**CITY OF BOULDER
LANDMARKS BOARD MEETING**

DATE: Wednesday, November 4, 2015

SUBJECT: Public hearing and consideration of an application for a Landmark Alteration Certificate to construct an addition to the building, replace non-historic windows and restore the historic façade of Whittier School at 2008 Pine Street, an individually landmarked property, per section 9-11-18 of the Boulder Revised Code 1981 (HIS2015-00243).

Figure 9: Proposed north entry detail.

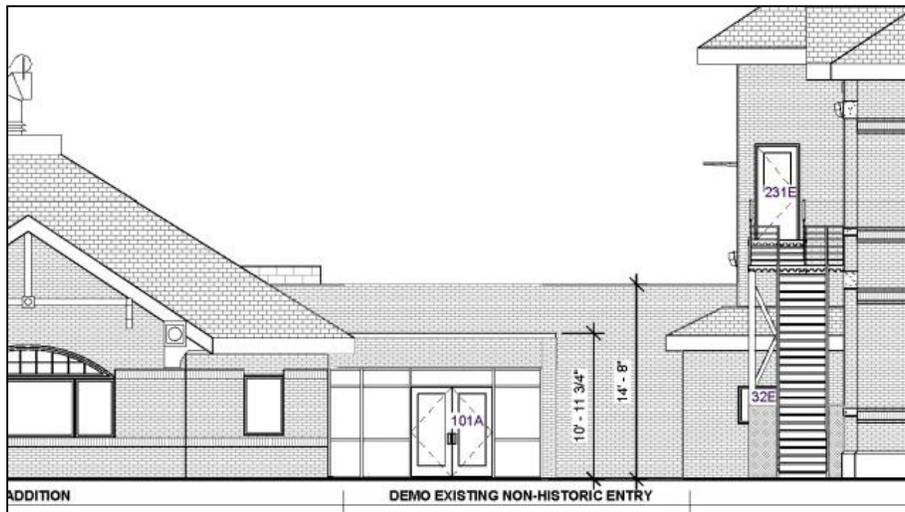
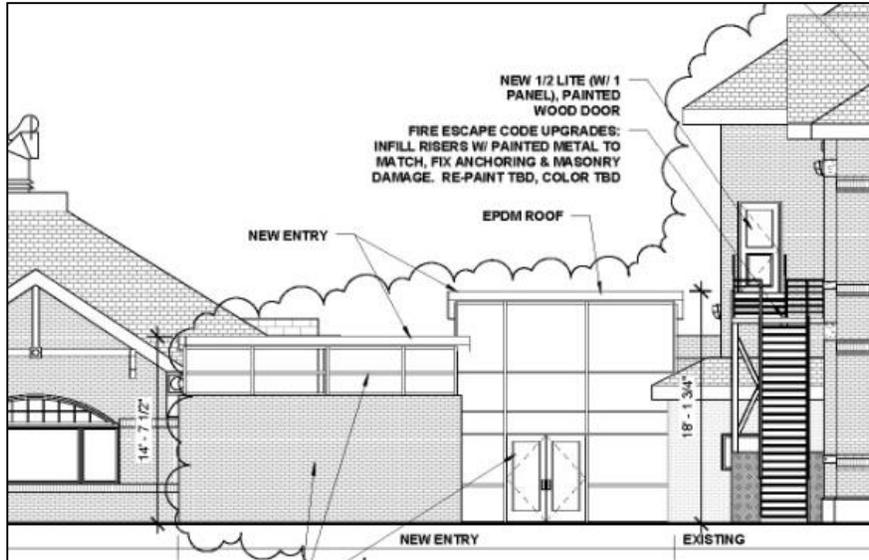
<i>loss of historic fabric and so that the character-defining features of the historic building are not destroyed, damaged, or obscured.</i>	historic material. Proposed addition will be transparent and provide views to west walls of 1882 and 1916 portions of building. Review details at Ldrc.	
.2	<i>New additions should be constructed so that they may be removed in the future without damaging the historic structure.</i>	Addition appears to be reversible. Review details at Ldrc.	
.3	<i>It is not appropriate to construct an addition that will detract from the overall historic character of the principal building and/or the site, or if it will require the removal of significant building elements or site features.</i>	Proposed glass entryway is contemporary and intended read as a transparent volume through which the historic school will be visible. Review details at Ldrc.	Yes

<i>in detail than the original structure. An addition that exhibits a more ornate style or implies an earlier period of architecture than that of the original is inappropriate.</i>	historic building.	
.4	<i>The architectural style of additions should not imitate the historic style but must be compatible with it. Contemporary style additions are possible, but require the utmost attention to these guidelines to be successful. The use of two distinct historic styles, such as adding Tudor-style half-timbering to a Classic Cottage, is inappropriate.</i>	Transparency provides compatibility. Review of proportions of glass segments might be designed in way to reference proportions found on historic portion of school. Review at Ldrc.	Maybe

.6	<i>Use window shapes that are found on the historic building. Do not introduce odd-shaped windows such as octagonal, triangular, or diamond-shaped</i>	Transparency provides compatibility. Review of proportions of glass segments might be designed in way to reference proportions found on historic portion of school. Review at Ldrc	Maybe
.7	<i>Do not add divided light windows to structures that historically did not have divided light windows.</i>	See .6 and .7 above	Maybe
.8	<i>Use materials and construction similar to historic windows. Do not use snap-in mullions.</i>	See .6 and .7 above. Staff considers metal and glass to be compatible given type of building and nature of transparent form to which the addition aspires.	Maybe

Staff considers the proposed removal of the c. 1980 entryway and construction of a new glass entryway that is more transparent to be generally consistent with the design guidelines. Care will need to be taken to detail the addition in a way that references and is compatible with the historic building. Staff suggests subtle

1. The applicant shall be responsible for undertaking the work in compliance with the approved plans dated September 16, 2015, except as modified by these conditions of approval.
2. Prior to submitting a building permit application and final issuance of the Landmark Alteration Certificate, the applicant shall submit the following:
 - a. Details showing the connection of the addition to the historic building to ensure reversibility;
 - b. Exploration of modifying the proportions of glass segments to be designed in way to reference proportions found on historic portion of school;
 - c. Final details on the restoration of the historic portion of the school;
 - d. Final details showing door and window restoration and replacement;
 - e. Final details on proposed wall materials, stair replacement, colors, and associated hardscaping.

Figure 18. Proposed west elevation, 2015.

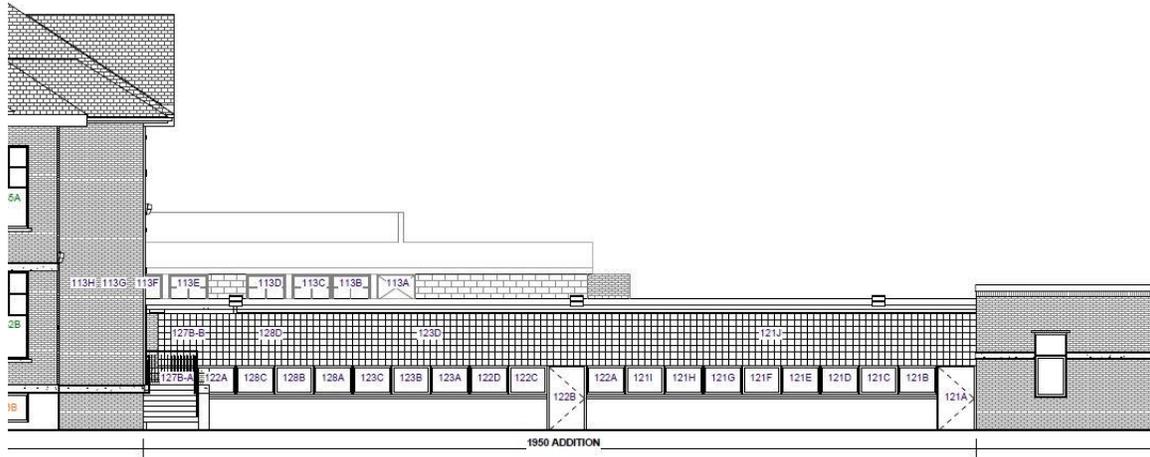
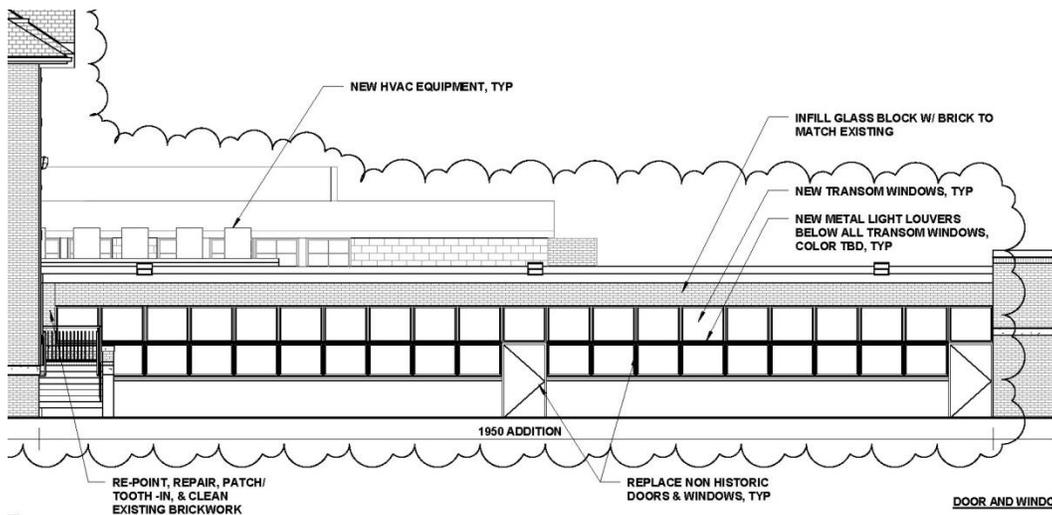
Applicant proposes the replacement of doors & windows on the 1950 addition of Whittier School. This includes the Gym clerestory windows and the infill portion of glass block on the west elevation. The 1950 addition is directly south of the 1916 addition and the 2010 addition abuts the south of the 1950 addition. The request calls for replacement with energy-efficient insulated windows with a metal storefront and will have painted metal light louvers.

The proposal to rehabilitate historic windows and to replace non-historic windows is the result of a detailed window and door inventory undertaken by the architect. Staff considers the approach to be consistent with Sections 3.7 and 3.8 of the *General Design Guidelines*. Restoration of the historic building including repointing and reconstruction of the front doors based on historic photos will enhance the historic character of the school. Staff considers replacement of and continued use of exterior stairs necessary to the functioning of the school. Details of the windows and door work, masonry restoration and stair replacement should be reviewed by the Landmarks design review committee as a condition of approval.
